**Subject: Clean Harbors, FLD 980 729 610, Hazardous Waste Operating Permit No.
64247-HO-14
Polk County
First Notice of Deficiencies**

Your application for a hazardous waste permit (that includes your solid waste operating conditions (combined permit)) has been reviewed and found to be incomplete. The required information and amendments necessary to complete your application are itemized in the enclosed Notice of Deficiencies. Please note that a review of your Solid Waste Permit application will be sent under separate cover.

Clean Harbors FLD 980 729 610
Operating Permit No. 64247-HO-0012
Polk County

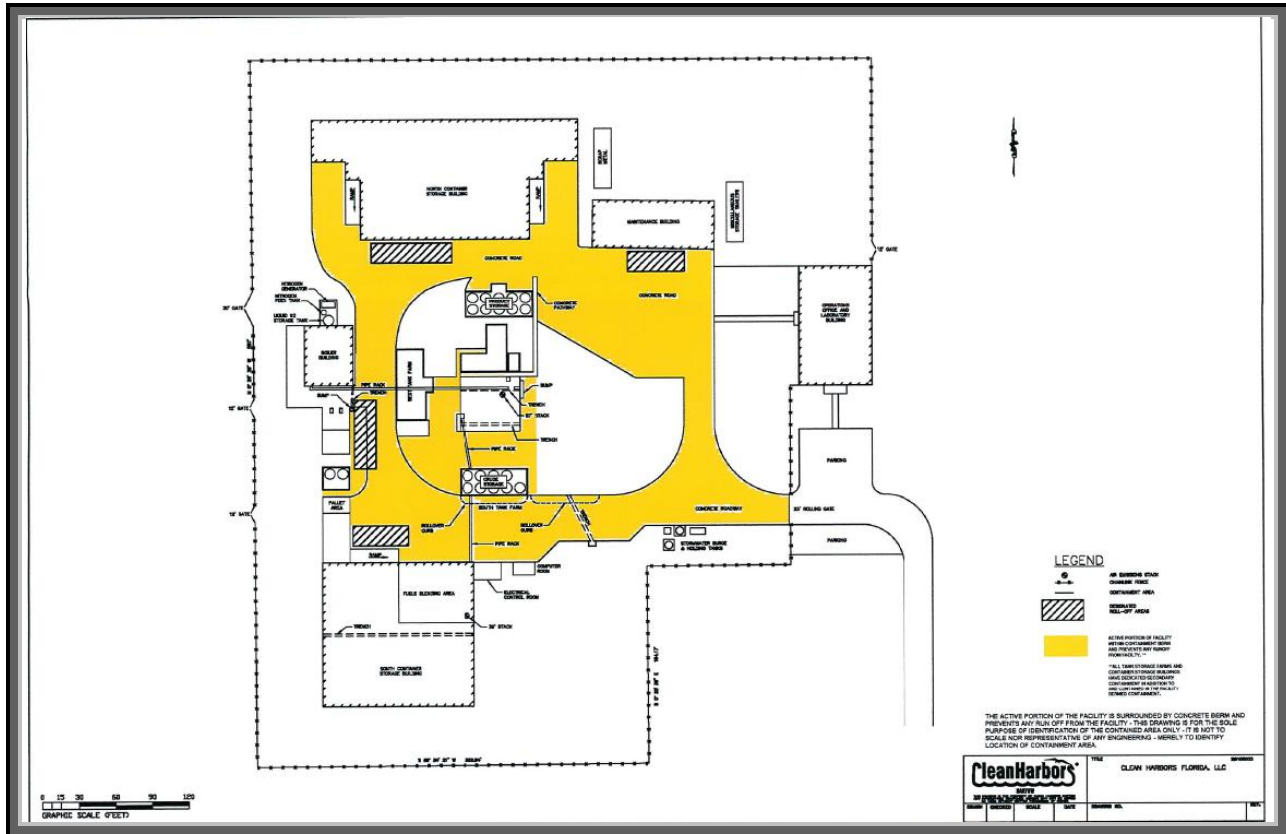
6. Part I.B.4 (Appendix D or D.1): This section references Appendix D but there is only an Appendix D.1. Appendix D.1 includes the "Physical Setting Source Map" that appears to be a more recent version of the "Known Water Wells" map that was submitted with the last Part B:

1. Contours are not legible on the map.
2. The location of Clean Harbors must be identified on this map.
3. A number of the items identified in the legend are not illustrated on the map. Either add these to the map or remove them from the legend if they are not illustrated on this map.
4. The legend has an icon that is a circle within a circle, and called "Cluster of Multiple Icons" I believe this should be "Cluster of Multiple Wells".
